**Planning Application 23/03875/APP by Statera Energy (the Applicant)**  
***Development of a battery energy storage system (BESS), connected directly to the national Grid with associated infrastructure including access, drainage and landscaping.***

***Rookery Farm, Granborough, Buckinghamshire, MK18 3NJ***

## ***Consultation Response by East Claydon Parish Council***

**Fig. 4.2 EA designated Flood Zone 3 areas**

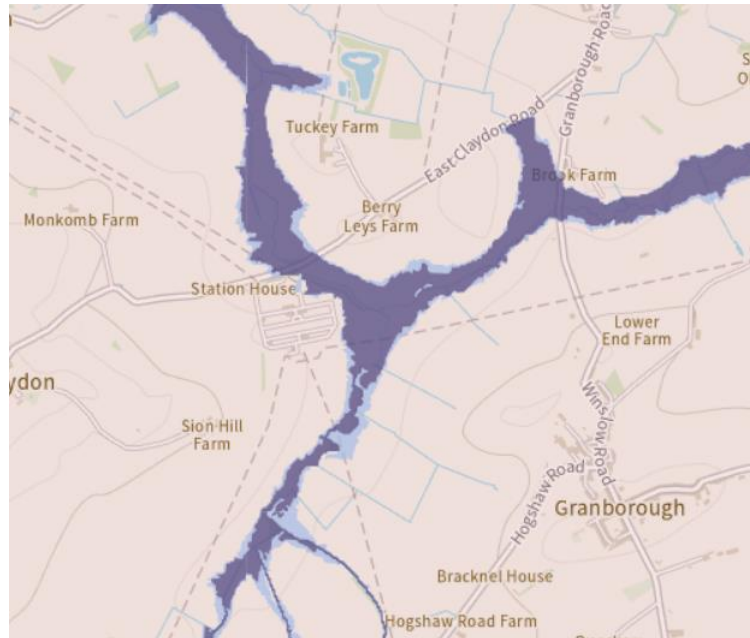
The Flood Risk assessment is based on the EA Flood Zone estimates but, as the email from the EA confirms in Appendix A, those zones are based on very limited information and may be unsound. By concentrating solely on the site (as defined by the area proposed for permanent development), the Applicant has ignored the wider area designated as Flood Zone 3 (dark blue area in the figure below) which includes the proposed temporary haul route from East Claydon Road. Note also that the Flood Zone 3 area extends to Tuckey Farm, the site of an application granted for a solar energy installation (see 21/04255/APP) and so the cumulative impact is of particular concern.

We can find no reference to consideration of any change in risk of flooding outside the proposed development site as a result of construction, operation or decommissioning activities. In the absence of such consideration, how can the Applicant conclude that risk elsewhere has not been changed?

**Fig. 10.1 Areas hatched in red indicate membership of the Countryside Stewardship Scheme (Source Magic Map).**

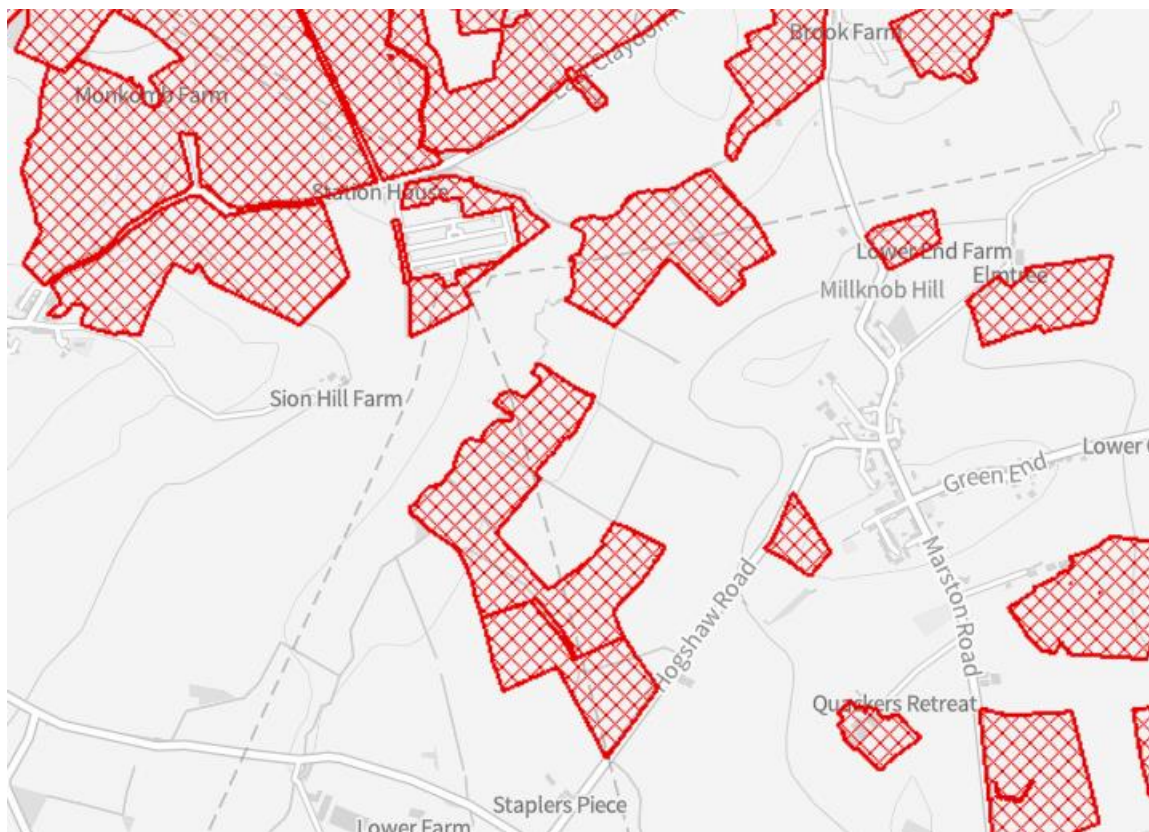
The proposed development site and much of the surrounding land include large parcels subject to the Countryside Stewardship Agreement areas (see Fig. 10.1). We have found no reference to this in the Applicant's submissions; rather there is a bias towards dismissing the habitat value of the setting.
